Access Compliance Report

Public Rights-of-Way

(Curb Ramps)

Intersection ID: 10468	Main Street: E_35TH_ST	Cross Street: WHITING_AV	Location: NW
ADA ID: 0A2EA07E6312	Ramp Type: Perp	Initial Pass/Fail: Fail	Overall Compliance: No
Severity Score: 22.5			
Codes/Mitigation Info/Possible Solution		Field Measurements/Component Compliance

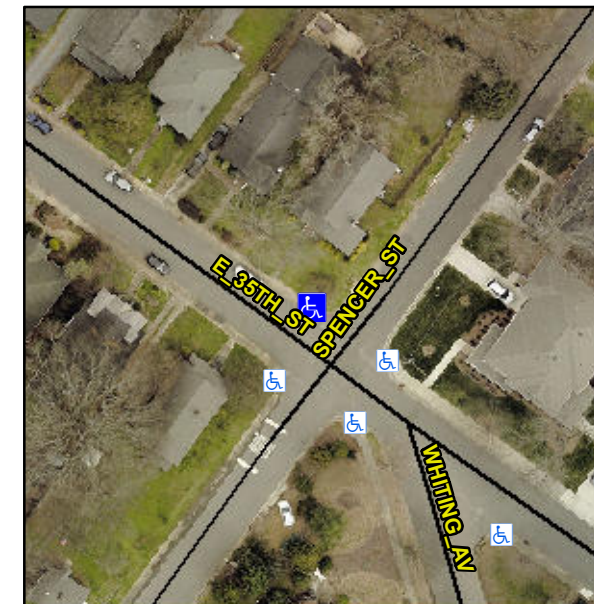
Not Found, R304.5.1, R304.2.2

Compliance	Description	Data	Compliance	Description	Data
N/A	Ramp Length (in)	52.0	No	Ramp Slope (%)	11.1
No	Ramp Width (in)	46.0	Yes	Ramp XSlope (%)	2.2
N/A	Flare Type LT	N/A	N/A	Flare Type RT	N/A
N/A	Flare Slope LT (%)	N/A	N/A	Flare Slope RT (%)	N/A
N/A	Flare Traversable LT?	N/A	N/A	Flare Traversable RT?	N/A
N/A	Landing Length (in)	N/A	N/A	DWS Provided?	N/A
N/A	Landing Width (in)	N/A	N/A	DWS Contrast?	N/A
N/A	Landing Slope (%)	N/A	N/A	DWS Length (in)	N/A
N/A	Landing X Slope (%)	N/A	N/A	DWS Full Width?	N/A
N/A	Landing Curb? (Y/N)	N/A	N/A	DWS Offset (in)	N/A
N/A	Shared Landing?	N/A			
N/A	Gutter Ponding?	N/A	N/A	Gutter Slope (%)	N/A
N/A	Gutter Lip Ht (in)	1.5	N/A	Gutter X Slope (%)	N/A
N/A	Painted X Walk1?	No	N/A	Painted X Walk2?	N/A
	X Walk 1 Direction	To SE		X Walk 2 Direction	N/A
N/A	X Walk 1 Width (in)	N/A	N/A	X Walk 2 Width (in)	N/A
	X Walk 1 Slope (%)	4.1		X Walk 2 Slope (%)	N/A
	X Walk 1 X Slope (%)	3.1		X Walk 2 X Slope (%)	N/A

Remove & Replace Entire Ramp.
